Before
UTTARAKHAND ELECTRICITY REGULATORY COMMISSION

Petition No. 35 of 2023

Application seeking approval of the Commission for the investment on the project "REVAMPED DISTRIBUTION SECTOR SCHEME" of Ministry of Power, Govt. of India in Uttarakhand to improve the quality, reliability and affordability of power supply to consumers through a financially sustainable and operationally efficient Distribution Sector by Reducing the AT&C losses to 12-15% and ACS-ARR gap to zero by 2024-25. Prepaid Smart Metering, Distribution System Strengthening/Modernization Works and other works as per scheme guidelines will also be covered under this scheme.

Date of Order: October 19, 2023

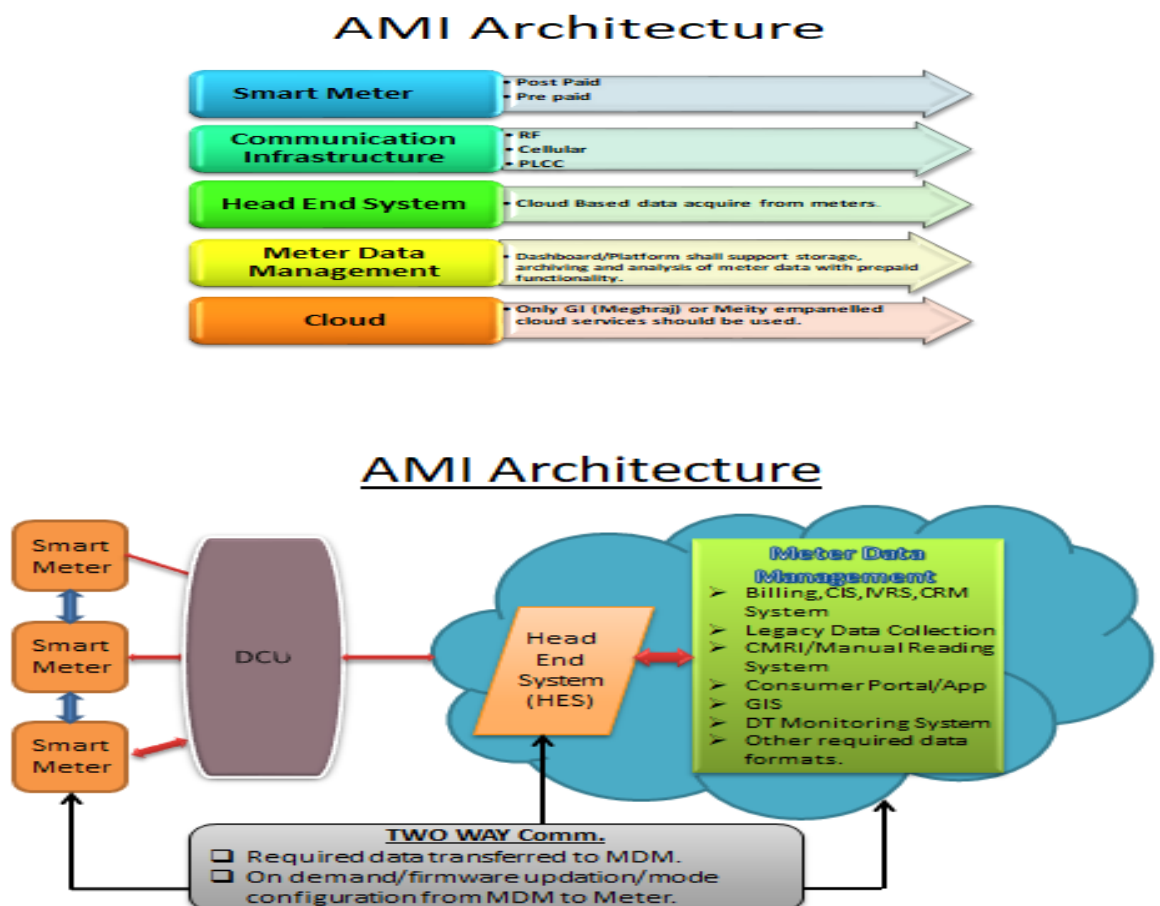
22. UPCL is required to furnish a block diagram/architectural drawing of communication system/meter data flow encompassing meter, modem, repeaters, data concentrators, Servers, DMS, SCADA, data storage, data recovery server etc.

11. With regard to UPCL's submission dated 25.07.2023 at point no. 22, UPCL is required to submit the Architectural drawing clearly indicating the no. of DCU, HES, modem, repeaters etc required in the system. Also confirm the location where the Data Recovery System & Data Center for the system shall be placed.

Reply:- The architectural drawing of communication system/meter data flow is mentioned underneath :-

Reply:- Architectural Drawing has already been submitted to Hon'ble commission in our previous submission dated 25.07.2023. Further the Smart Metering project is SLA linked and AMISP is responsible & shall maintain the SLA, hence No of DCU, HES, Modem, Repeater etc. has to be installed by AMISP in such a way and as per project requirement to maintain the pre-defined SLAs. Also the data flow and storage from Meter to HES is through DCU (In case of RF) is cloud based data center. Cloud service provider shall be provided and managed by AMISP.
